RE: Phased Subdivision Application for 6719 Devon Avenue SE (AMANDA 20-118048-LD)

PW Completeness Review_Civil Plans_Devon Estates.pdf Markup Summary

P401

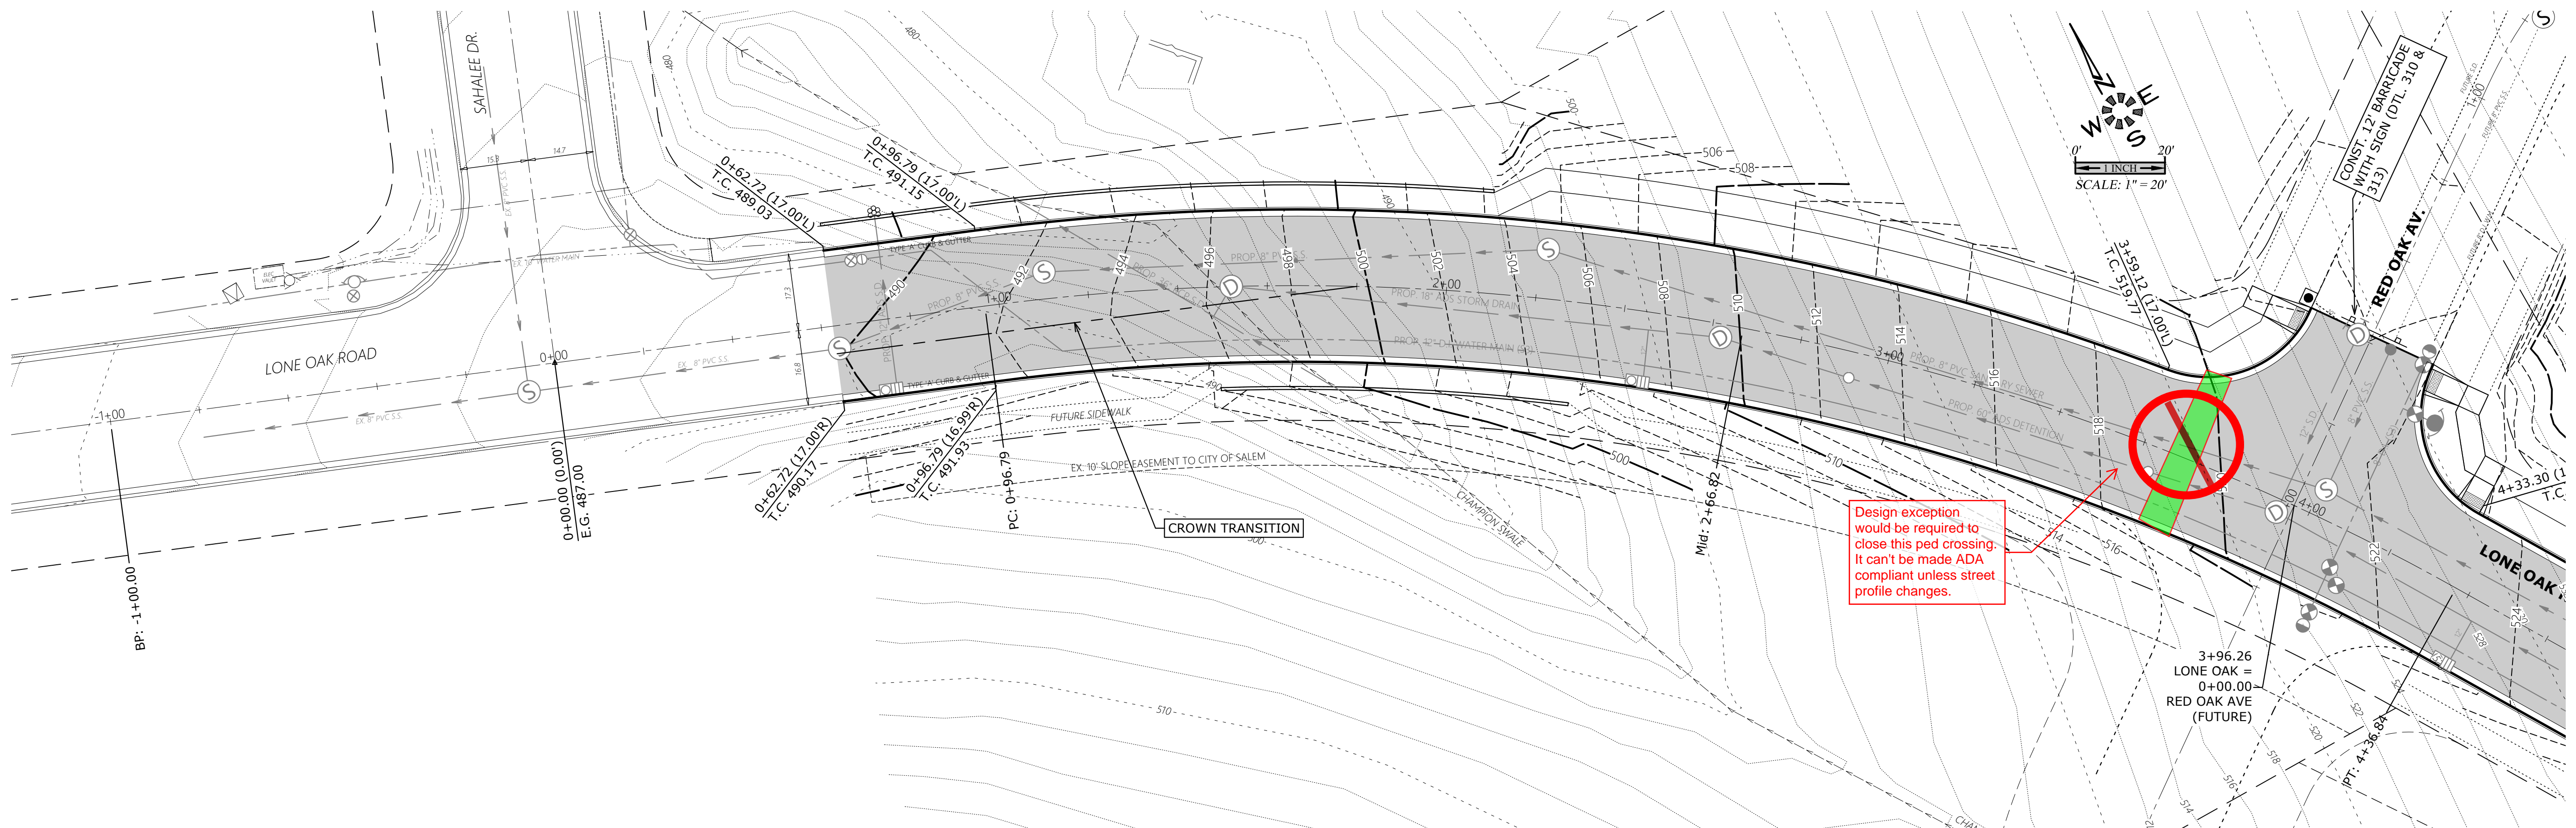
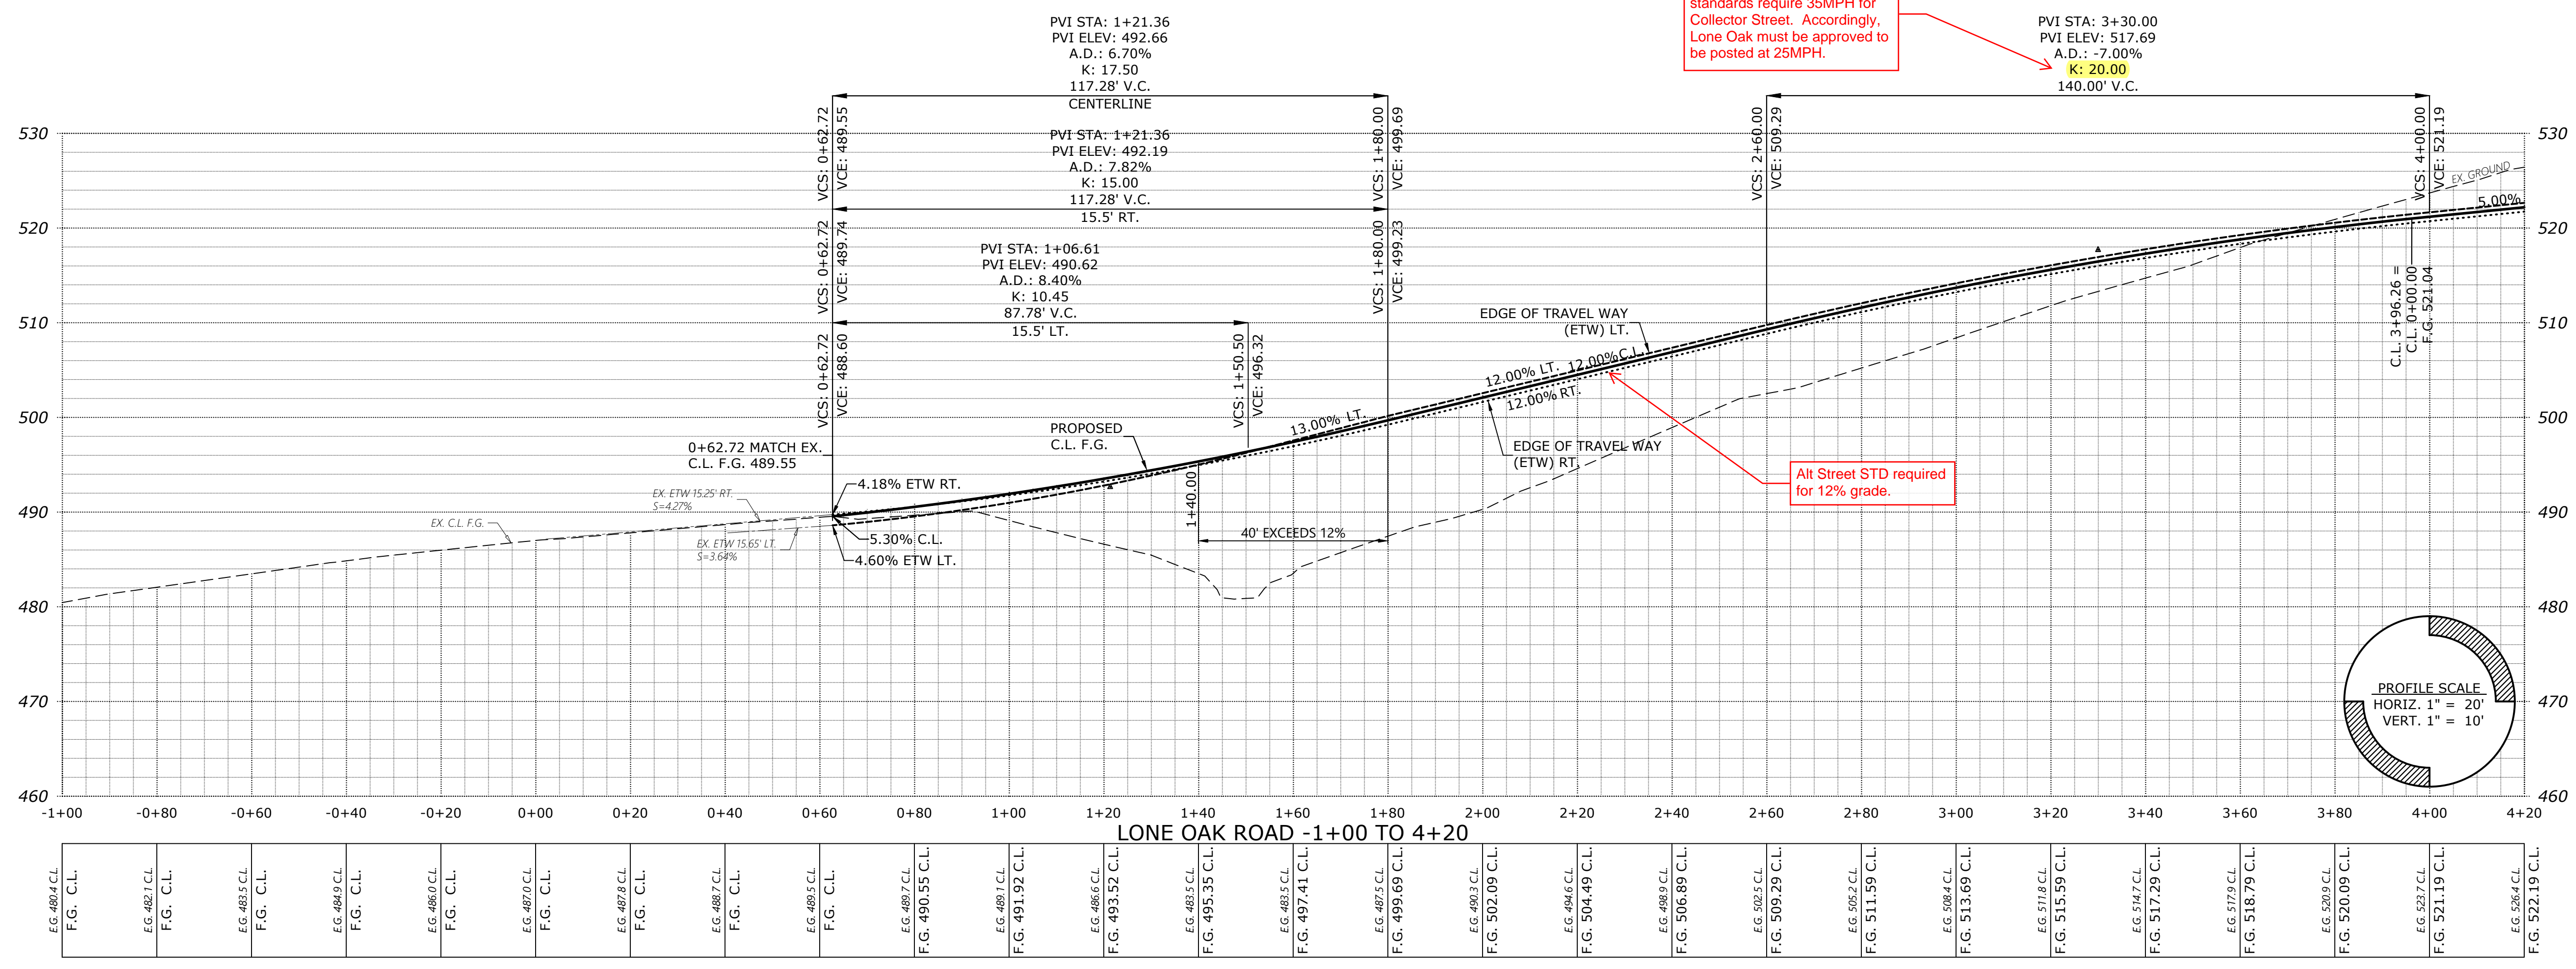
This vertical curve only meets 30MPH design speed where standards require 35MPH for Collector Street. Accordingly, Lone Oak must be approved to be posted at 25MPH.

Design exception would be required to close this ped crossing. It can't be made ADA compliant unless street profile changes.

Alt Street STD required for 12% grade.

P402

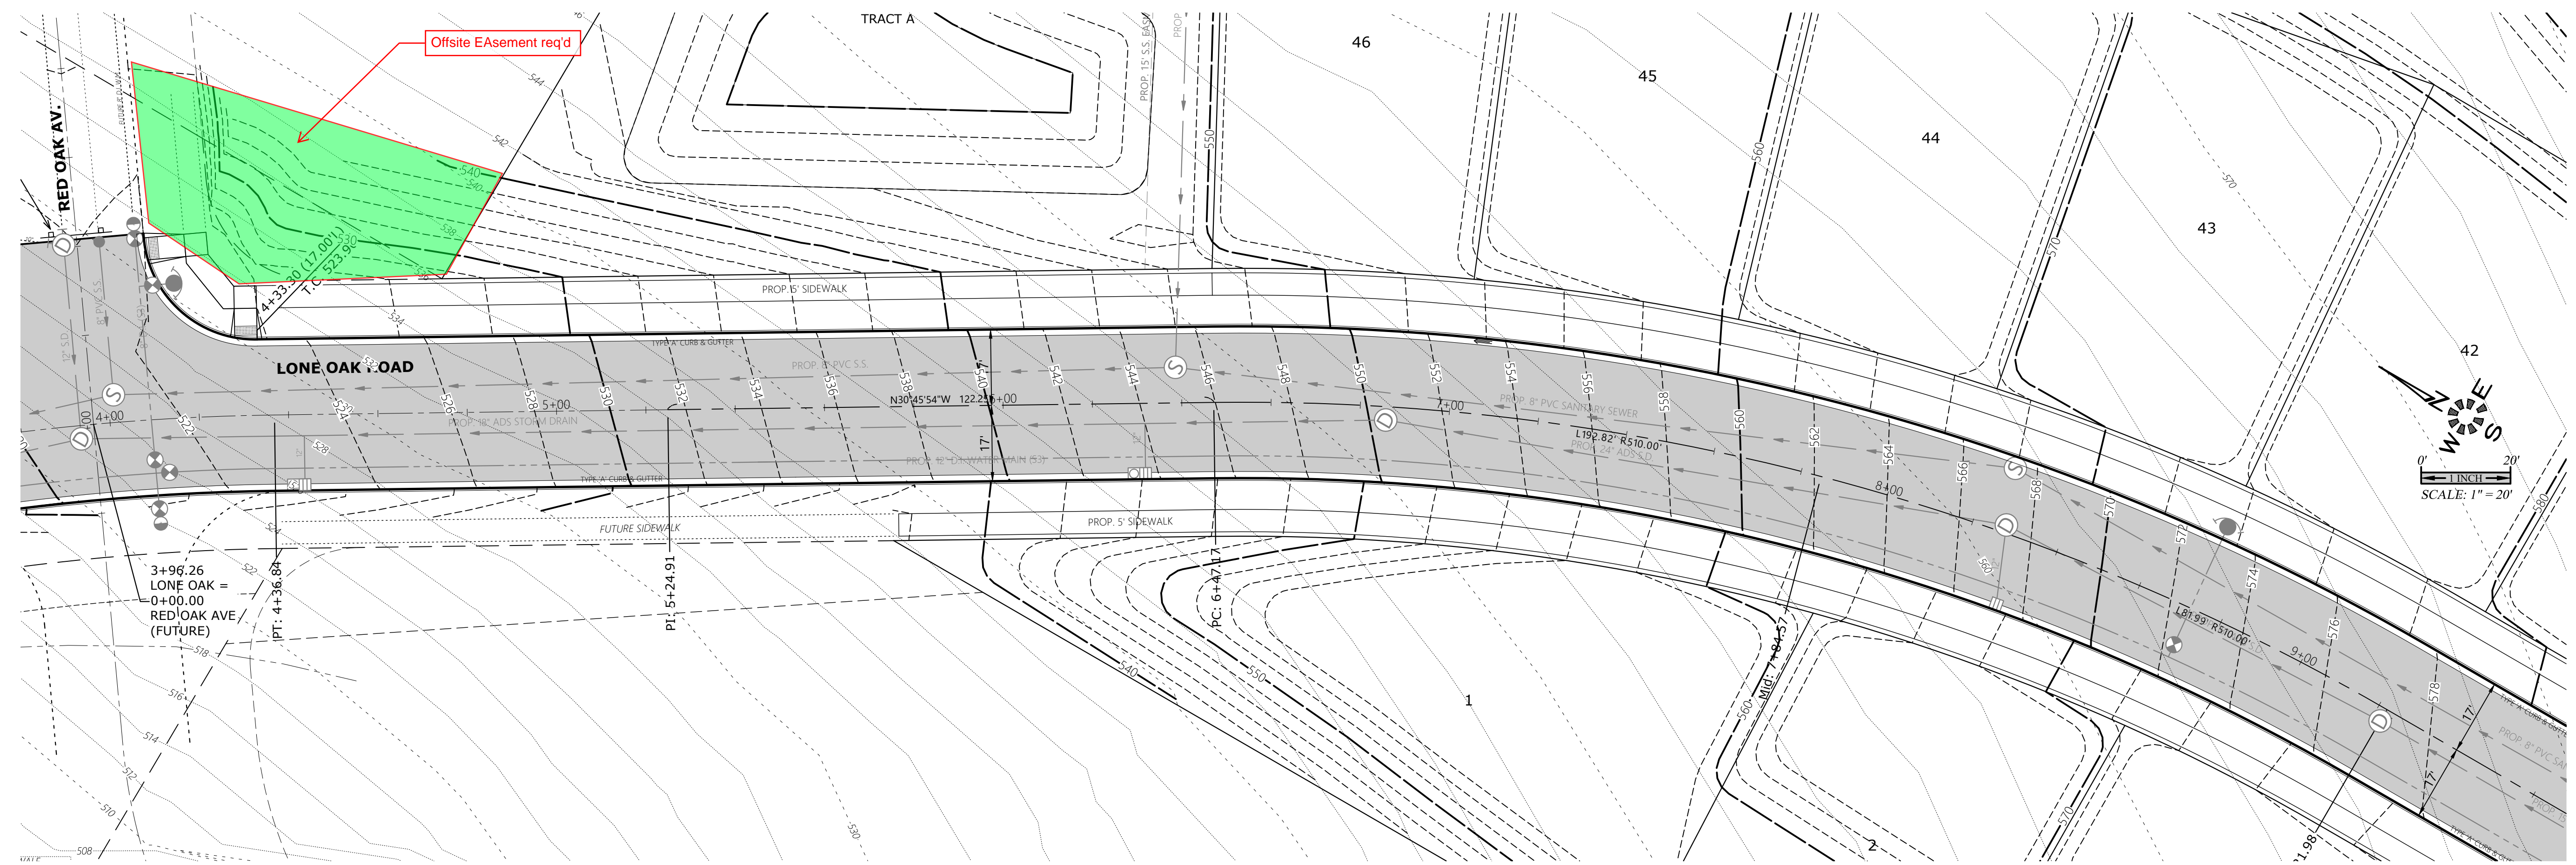
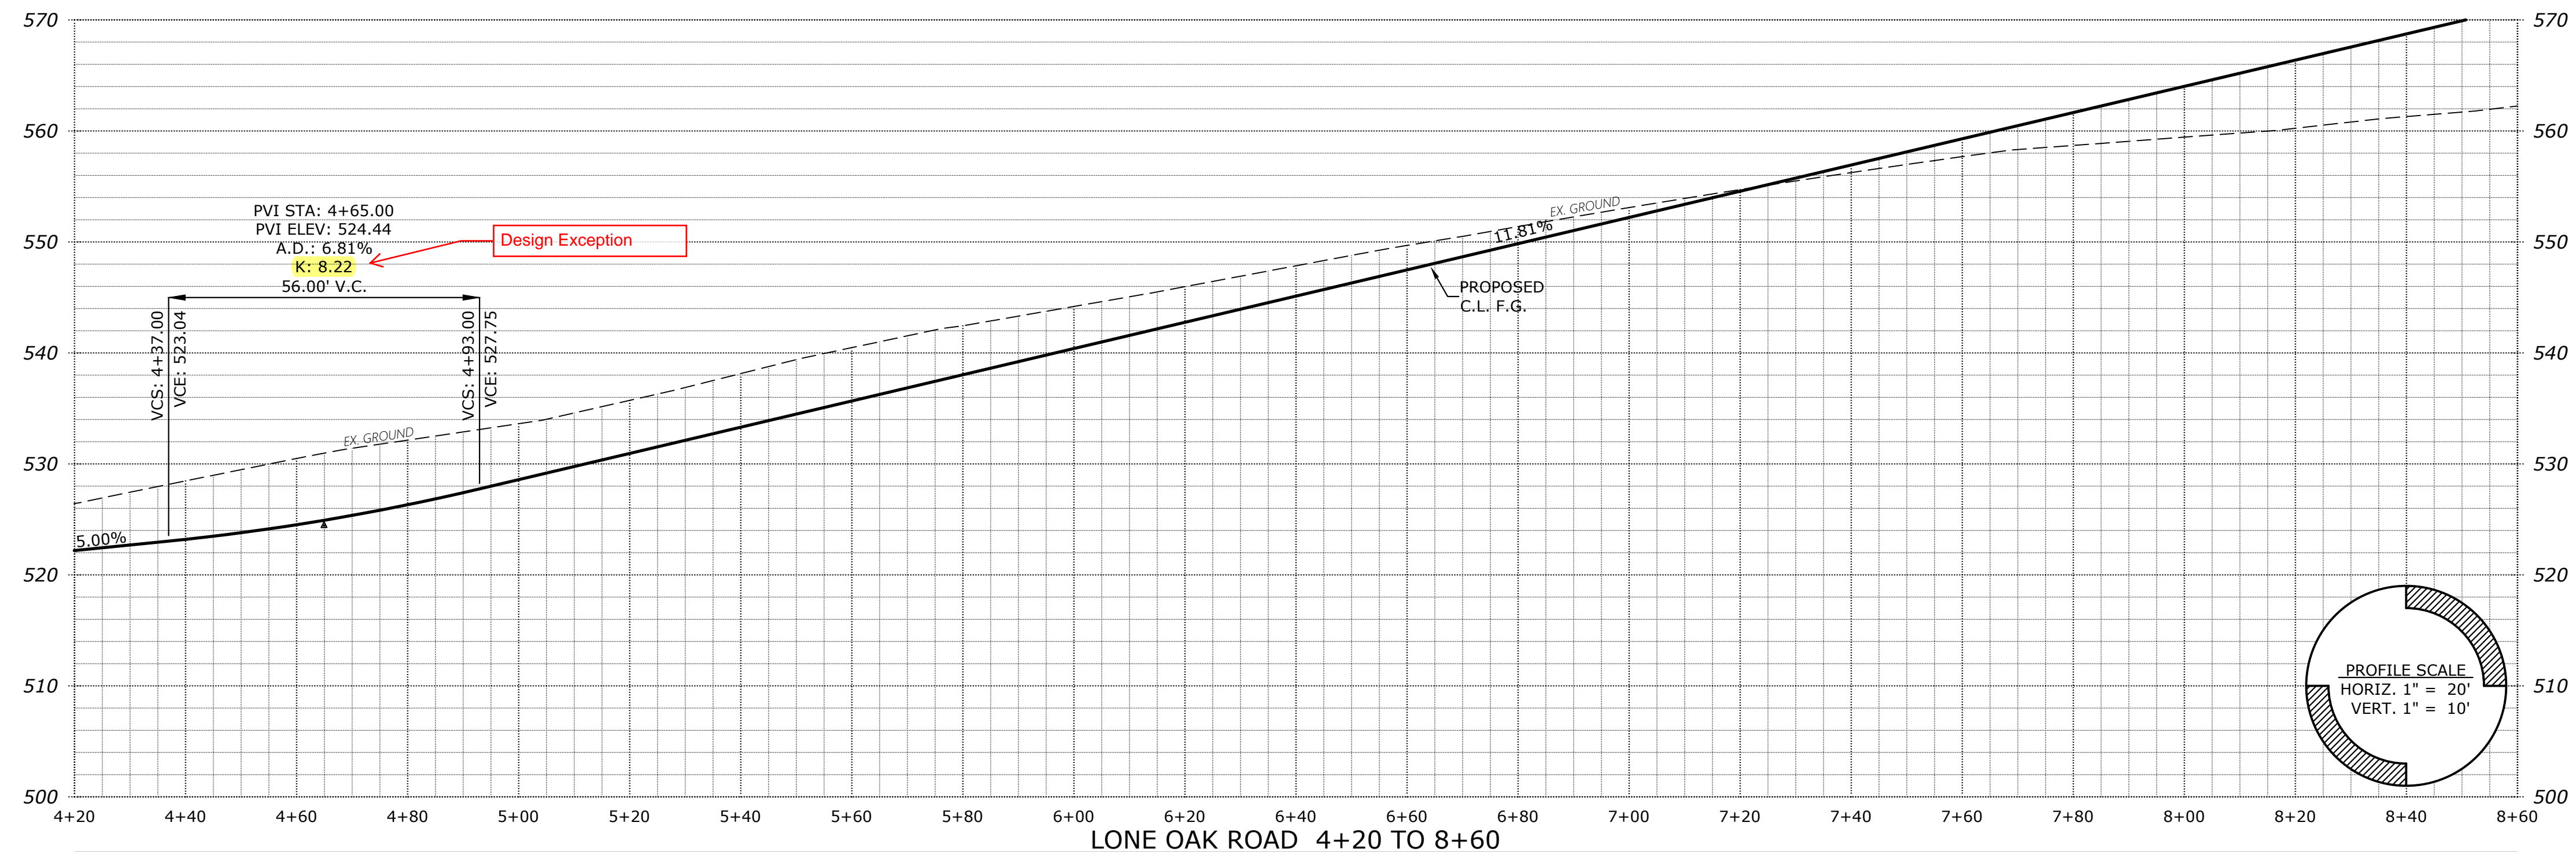
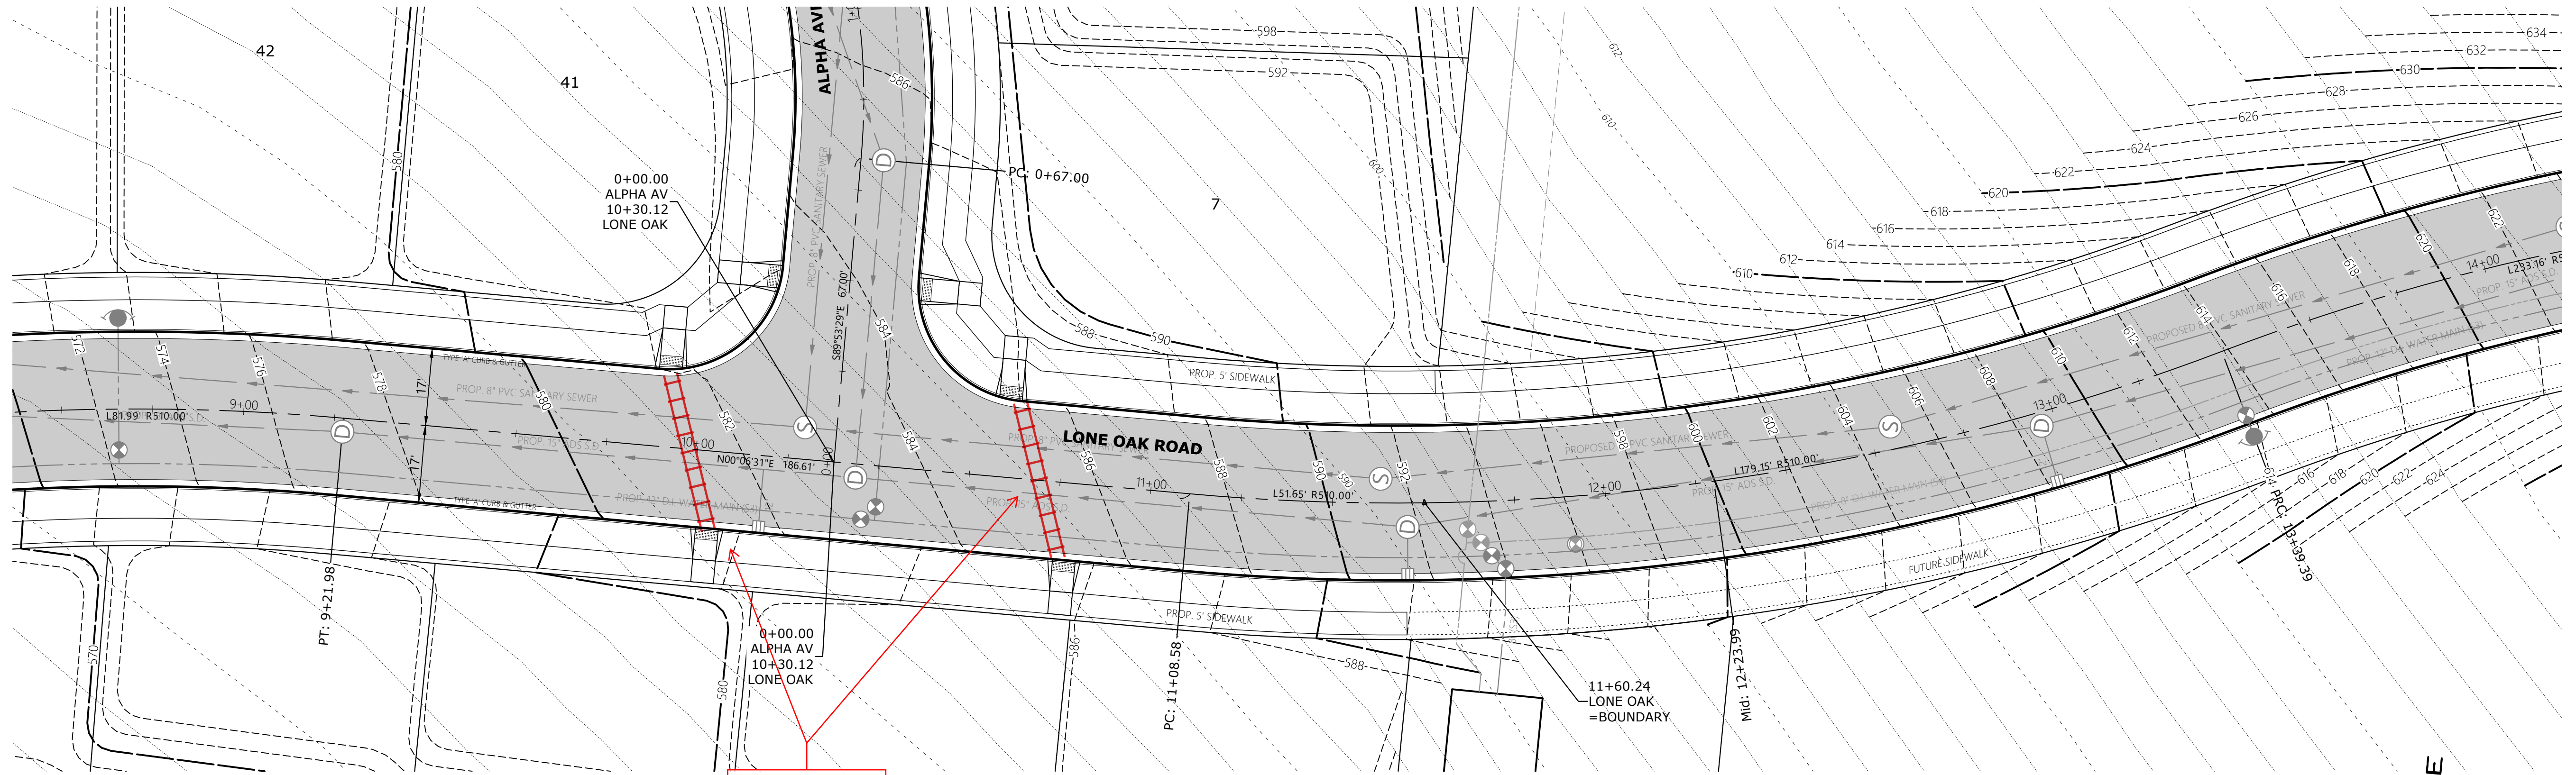
Design Exception

Offsite EAsement req'd
